BULLETIN NO. 2

Rocky Hill Intermediate School – Phase 2, Rocky Hill, CT

Rocky Hill Intermediate School Pre-Bid RFI Log – Bulletin 002
Updated: March 21, 2018

DATE: 03/19/18	DRAWN BY: KLS	DRAWING NO.:
SCALE: 1/8" = 1'-0"	PROJECT NO.: 17005.00	SKA2.01B

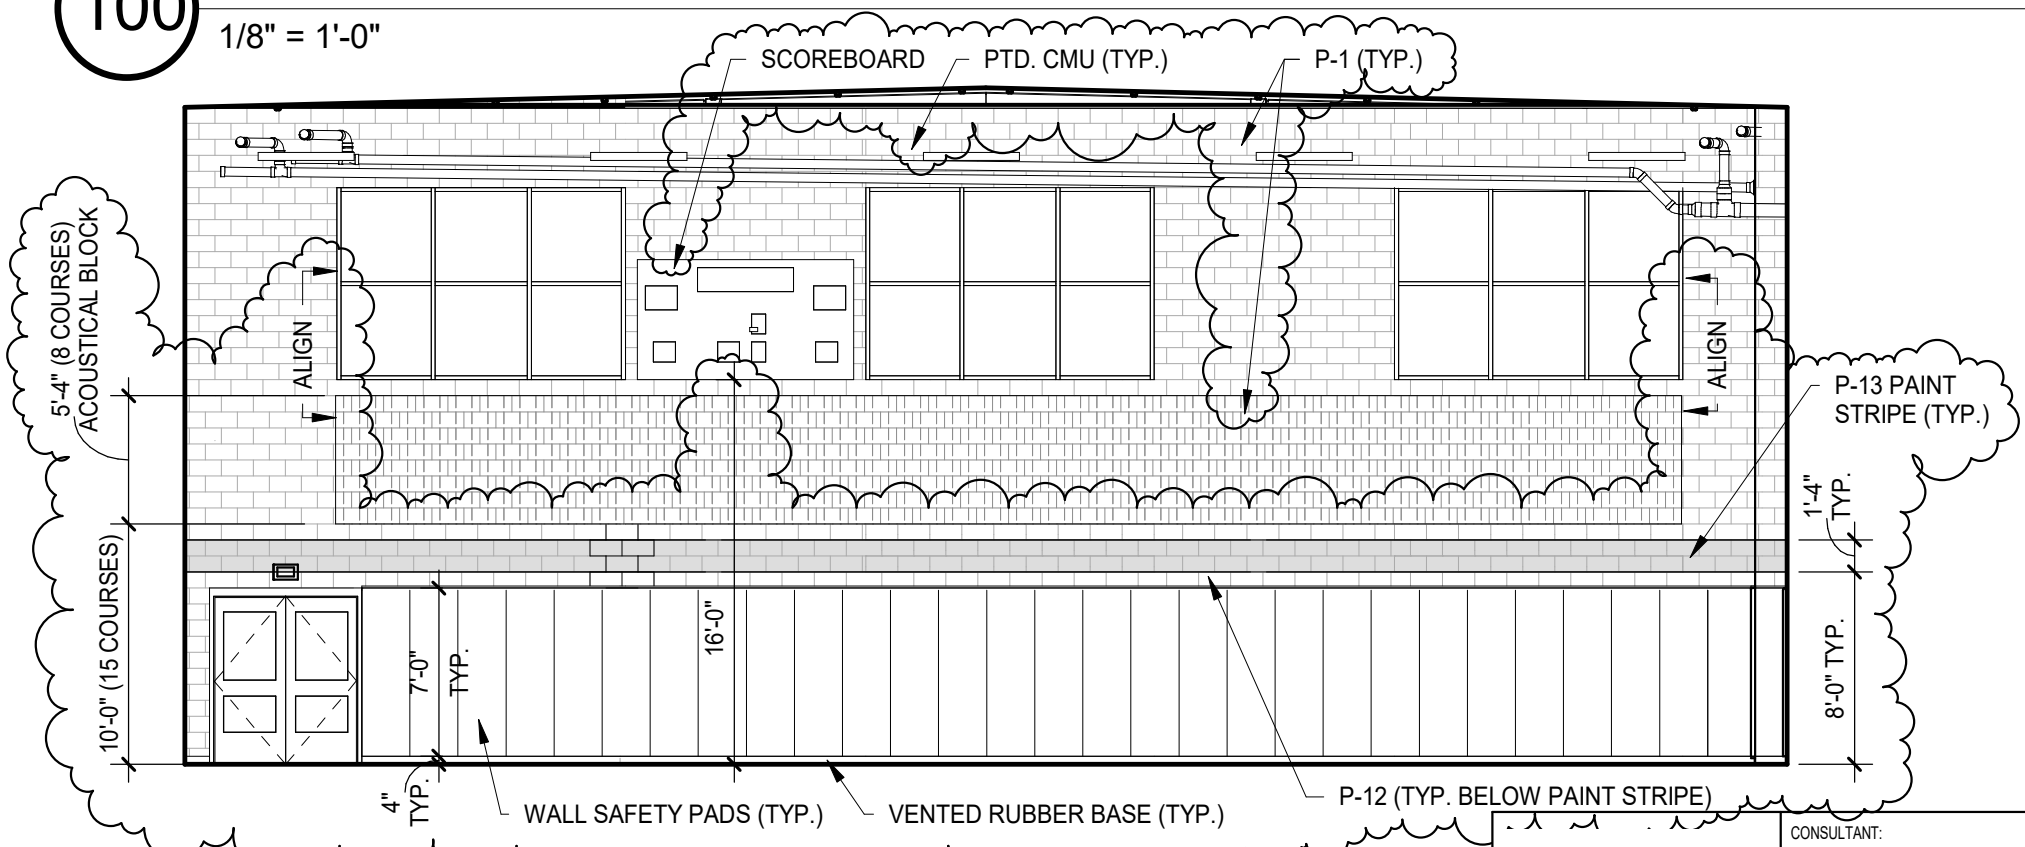
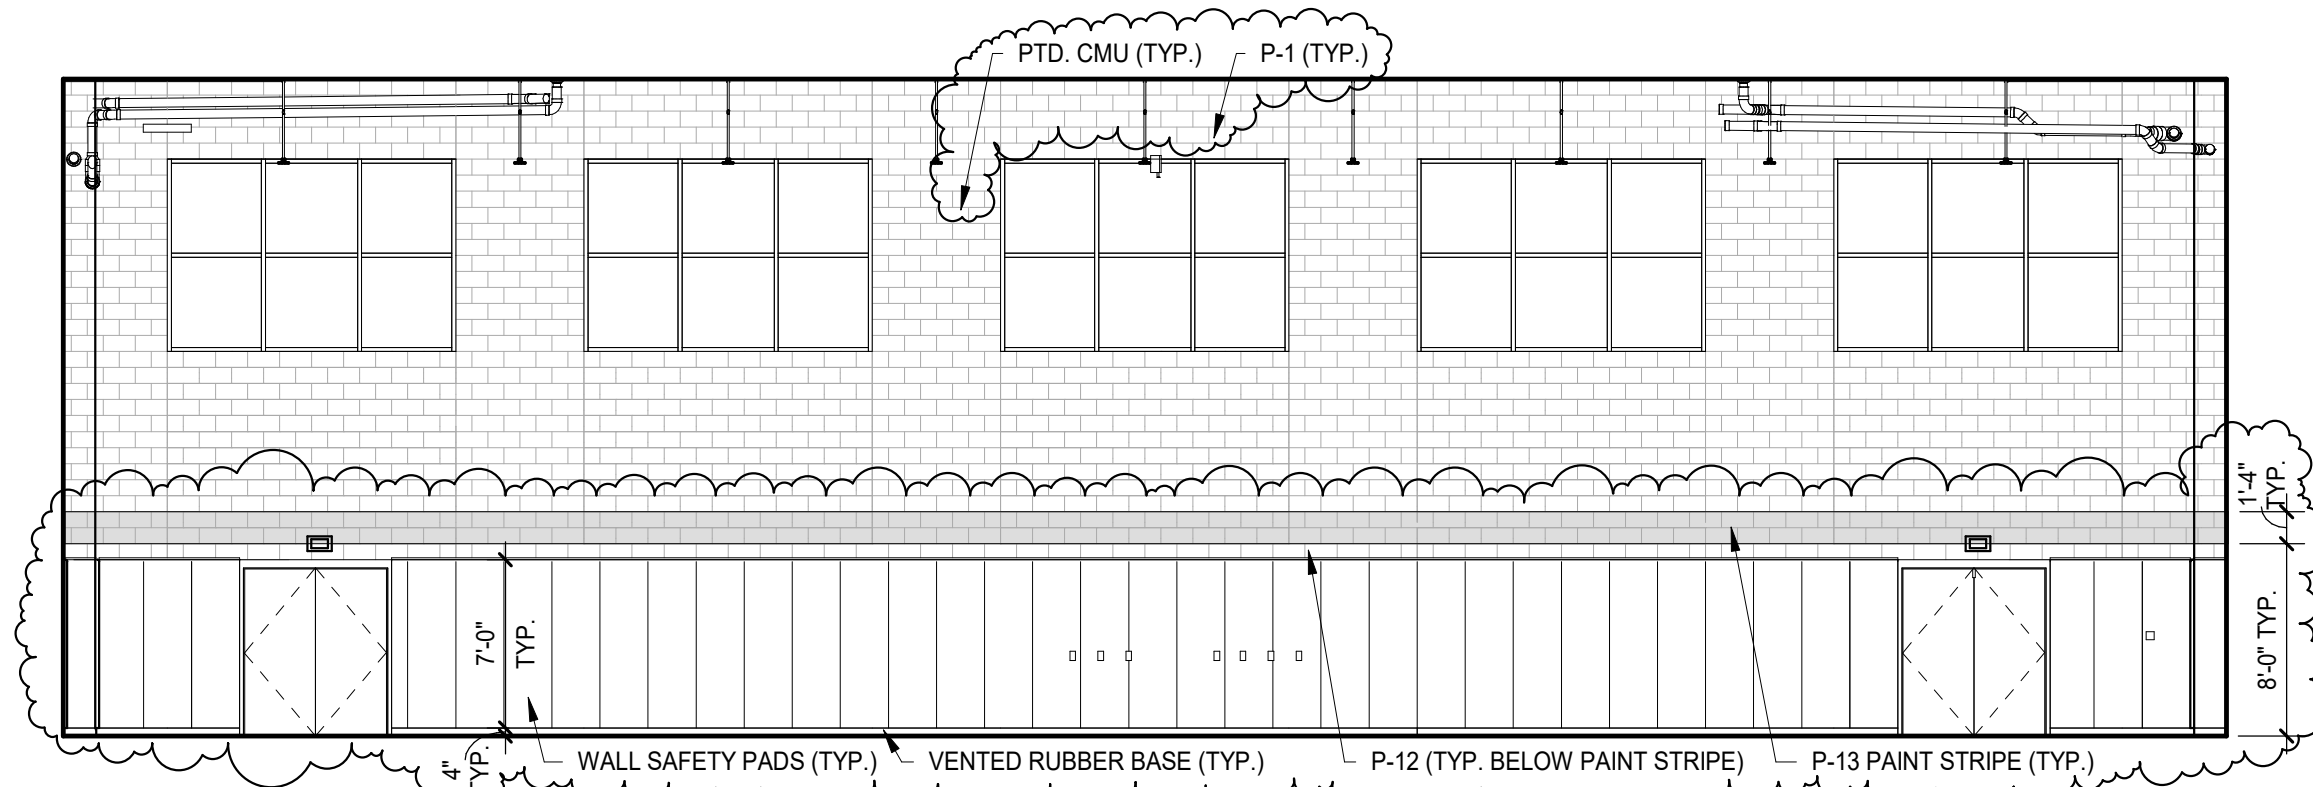
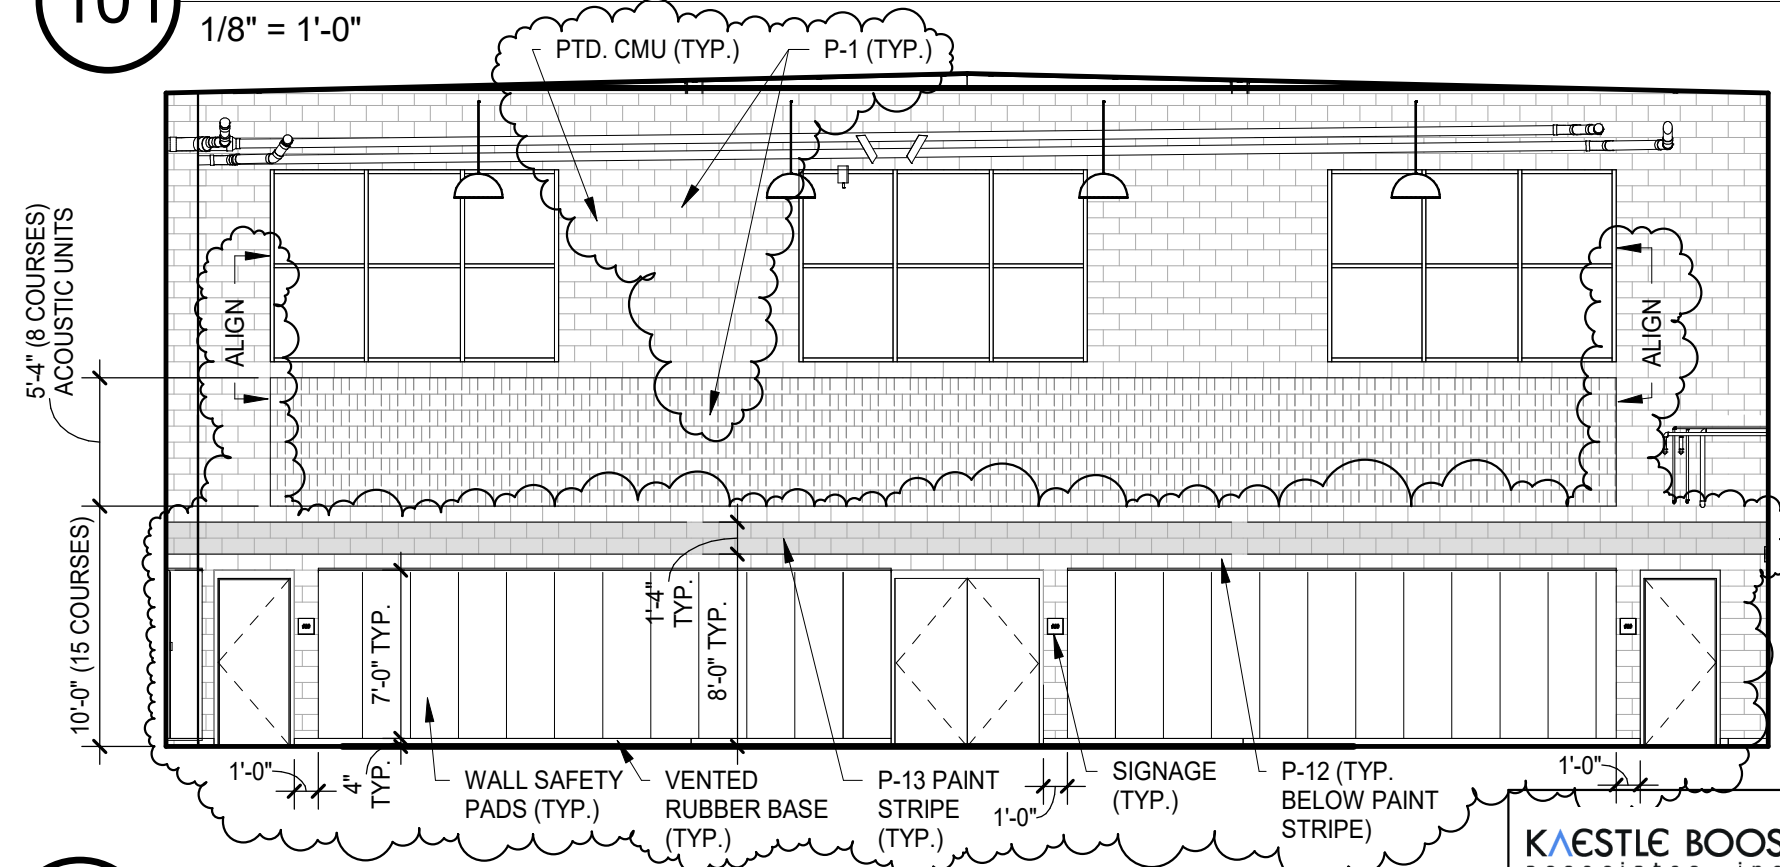
A10.08 INTERIOR ELEVATIONS VIII
See revised dimensions and material callouts on SKA2.01A & SKA2.01B

TITLE: **D101 GYM/ CAFETORIUM LOBBY
ENLARGED PLAN REVISIONS**

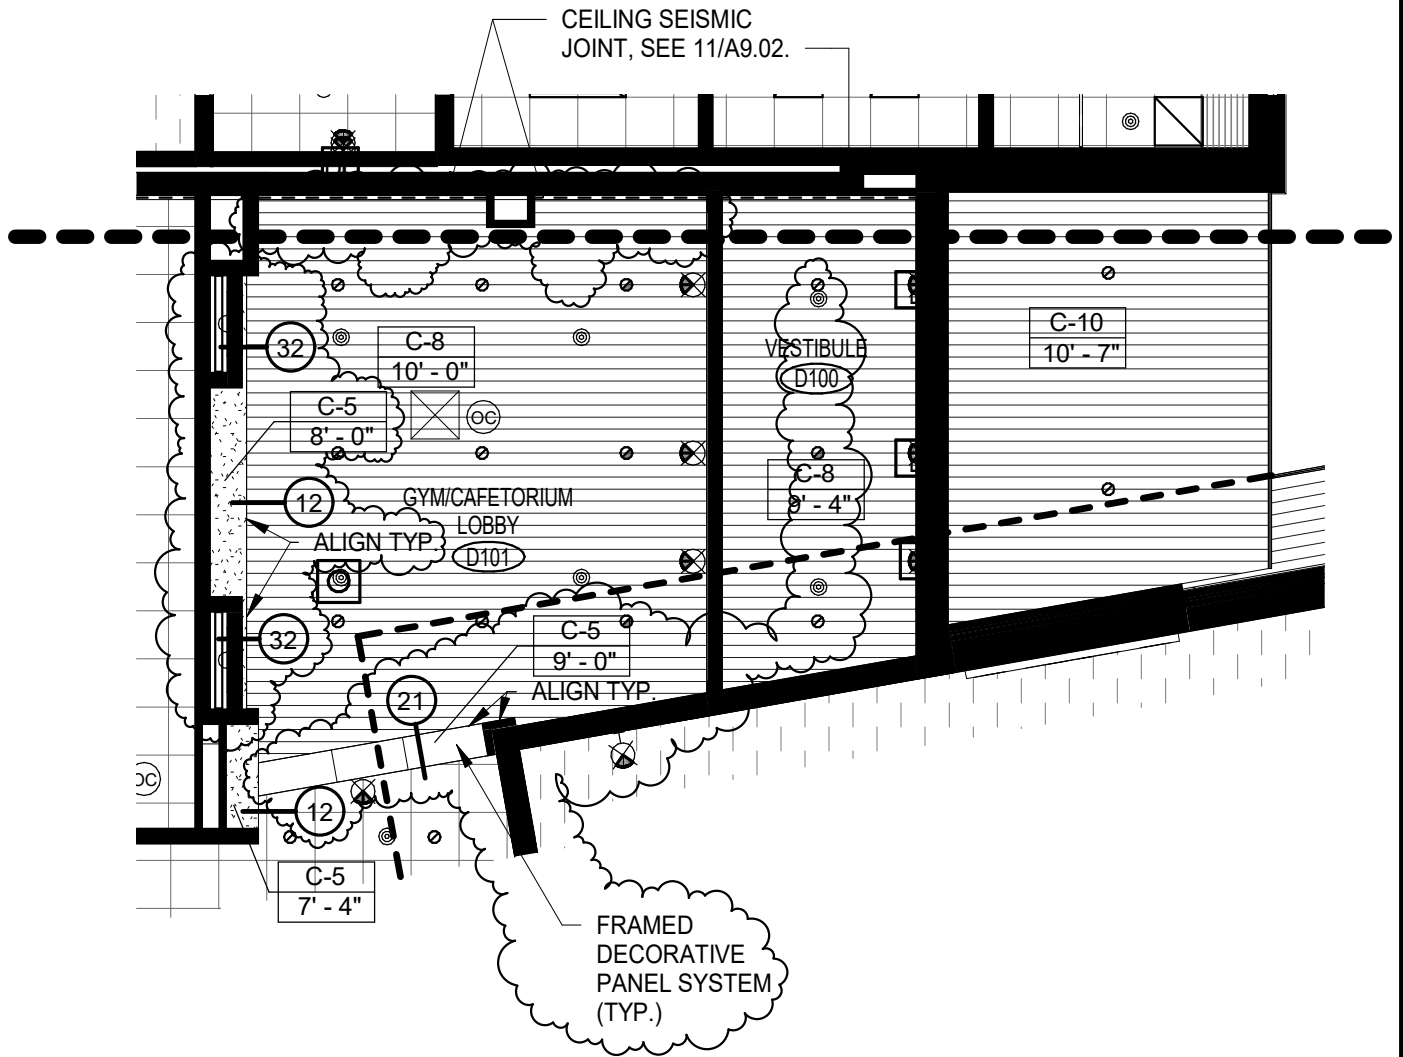
REFERENCE
DETAIL/SHEET: 10/A4.01

TITLE: **SOFFIT DETAIL**

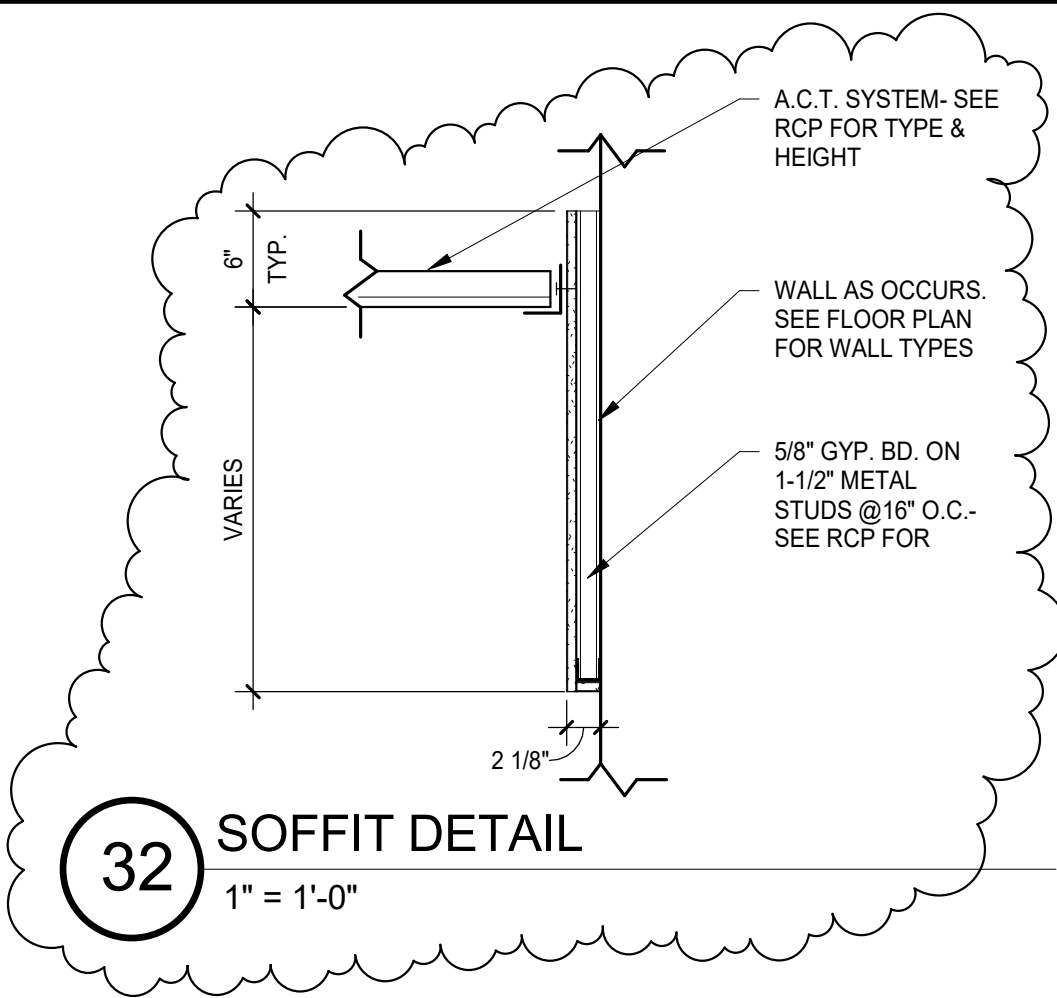
Add detail 32, see SKA2.05

15 SOFFIT DETAIL
1" = 1'-0"

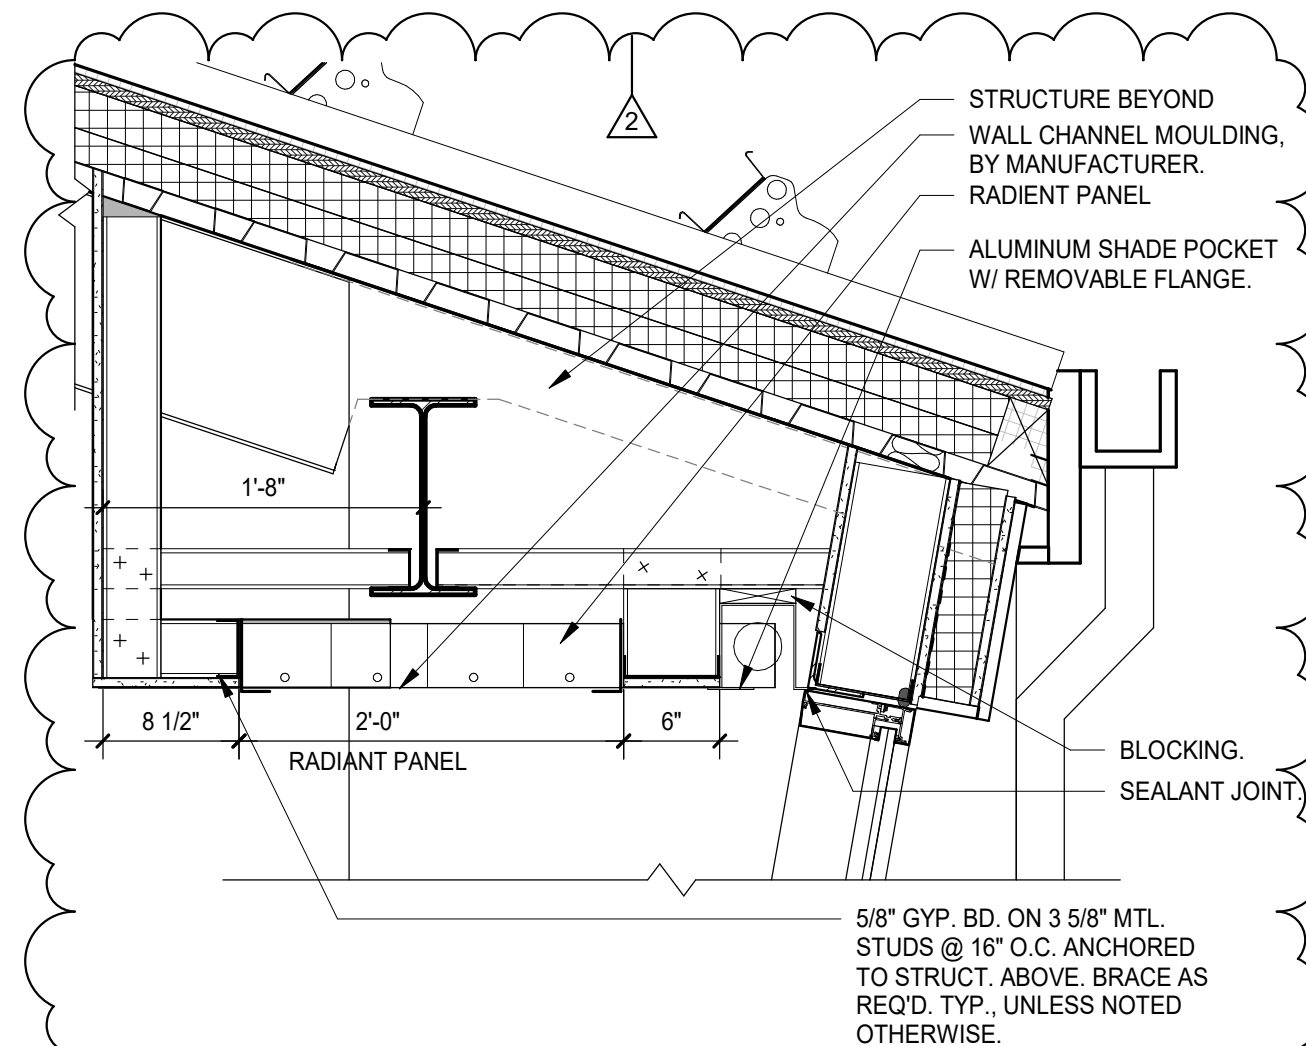
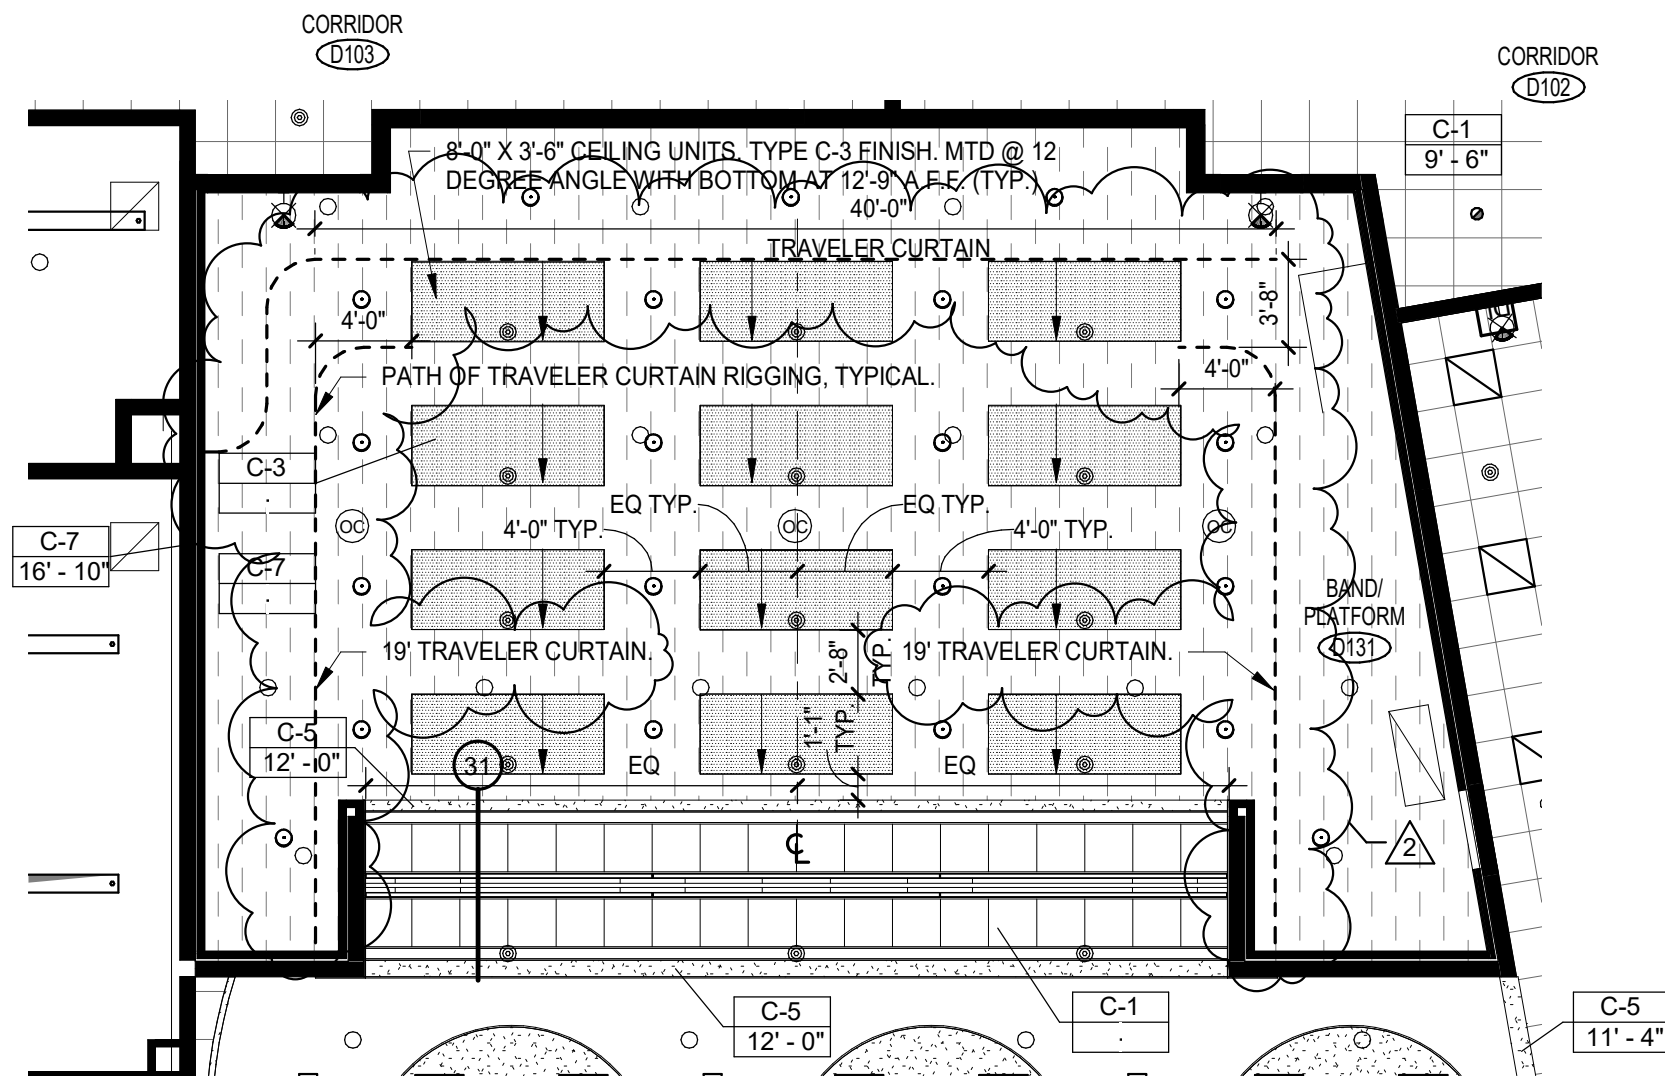
Revise detail 15, see SKA2.06
